Carburetor Vent Hose - 25 Four Stroke

Models Affected

2002 & 2003 Model Year	
USA	S/N OT409000 thru OT614773
Belgium	S/N OP153500 thru OP210462

a - Carburetor Float Bowl Vent Hose

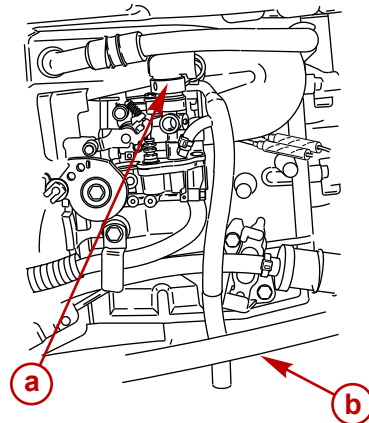
In certain situations, a small amount of fuel may exit from the carburetor float bowl vent hose when the outboard is fully tilted and turned on the starboard side. The cause may be that the carburetor vent hose has moved downward and is now out of position.

REPOSITION THE VENT HOSE AND RETAIN WITH STA-STRAP

Check that the vent hose is routed high and back against the electro thermo valve. If not, move the vent hose up towards the carburetor electro thermo valve. Use a 54-816311 sta-strap to secure the vent hose as high as possible and against the electro thermo valve. Outboards starting with USA serial number OT614774 & Belgium serial number 0P210463 have the sta-strap installed. The outlet of the vent hose should remain in the hole in the adaptor plate flange.

EXTEND VENT HOSE END

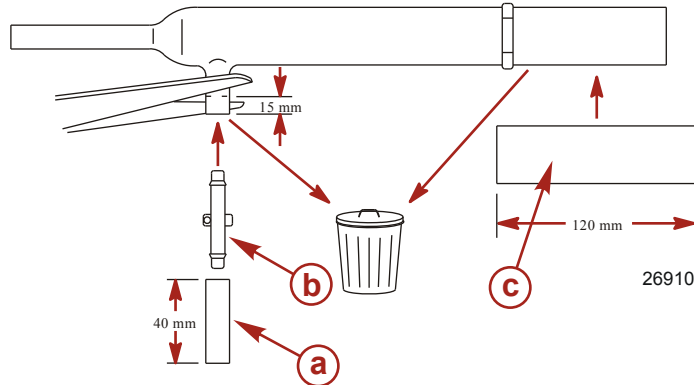
Boats with very steep transoms that allow the outboard to be tilted further forward may re-quire a slight modification to the existing carburetor float bowl vent hose.

Carefully pull the outlet end of the vent hose out of the hole in the adaptor plate flange. Re-move and discard the sta-strap and the 89 mm (3-1/2 in.) long hose extension from the end of the vent hose coupler. Cut a new 120 mm (4-3/4 in.) length of 32-856822-39 large hose. Install the new piece of hose on the connector and secure with a sta-strap 54-816311.

REASSEMBLY

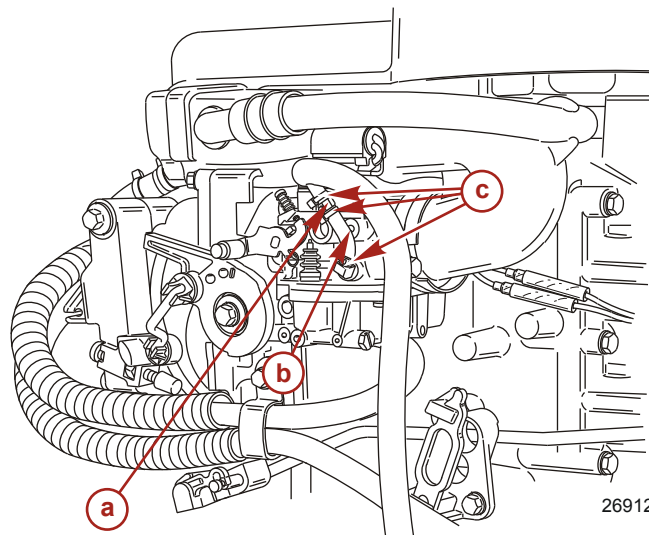
Remove the sta-strap and the vent hose from the starboard carburetor brass vent fitting. Reroute the vent hose behind the electro thermo valve. Cut 15 mm (0.59 or 19/32 in.) off the end of the existing vent hose that was connected to the carburetor brass vent fitting and discard. Cut a new 40 mm (1-9/16 in.) length of 32-99126-88 small hose. Connect the short-ened vent hose and the new small hose with a 22-822771 barbed fitting. Lubrication of the barbed fitting and the hose may be necessary for ease of assembly.

Assemble the new hose end to the carburetor brass vent fitting and install sta-strap 69355 in the three locations.
